Service Letter No. 430

SUBJECT: Inspection of Nose Gear Drag Link Assembly

MODELS AFFECTED: PA-30 Twin Comanches, Serial Nos. 30-1 to 30-394 inclusive

SERVICE LETTER NO. 430

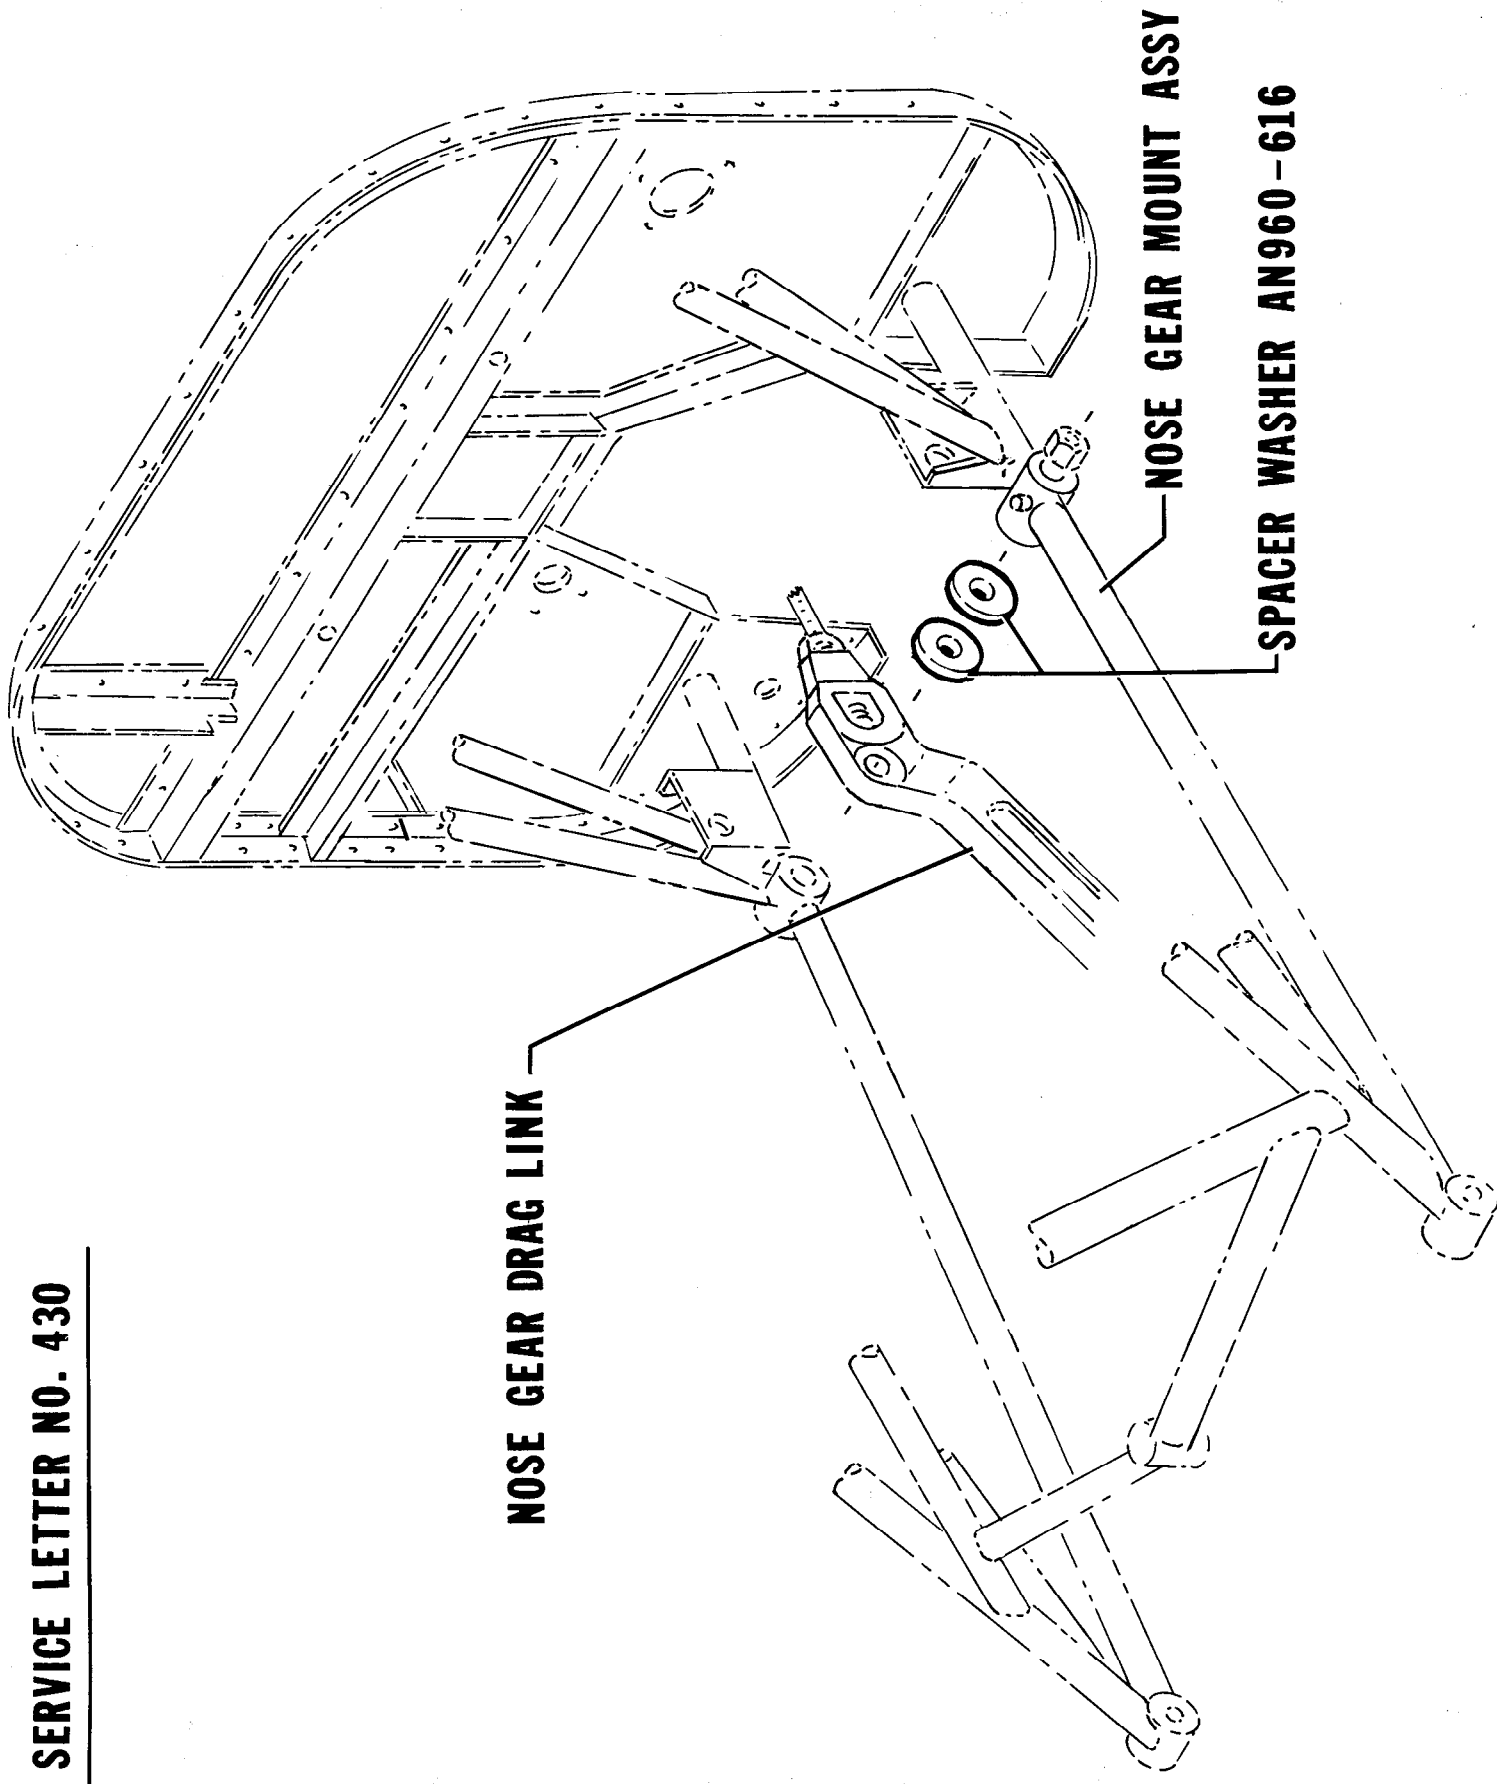
We have had reports indicating that nose gear drag link assembly, part number 23109-00, may contact fuselage bulkhead, part number 23834-00, during the retraction cycle. We recommend that an inspection for abrasion between these two assemblies be made.

If abrasion is found to exist, spacer washers -- not to exceed a maximum of two (2) #AN960-616 -- should be installed between the nose gear drag link and the nose gear mount assembly. See sketch on the reverse side of this service letter.

After spacer washers are installed, the landing gear system should be checked, with both the electrical and manual extension systems, to be sure there is no binding.
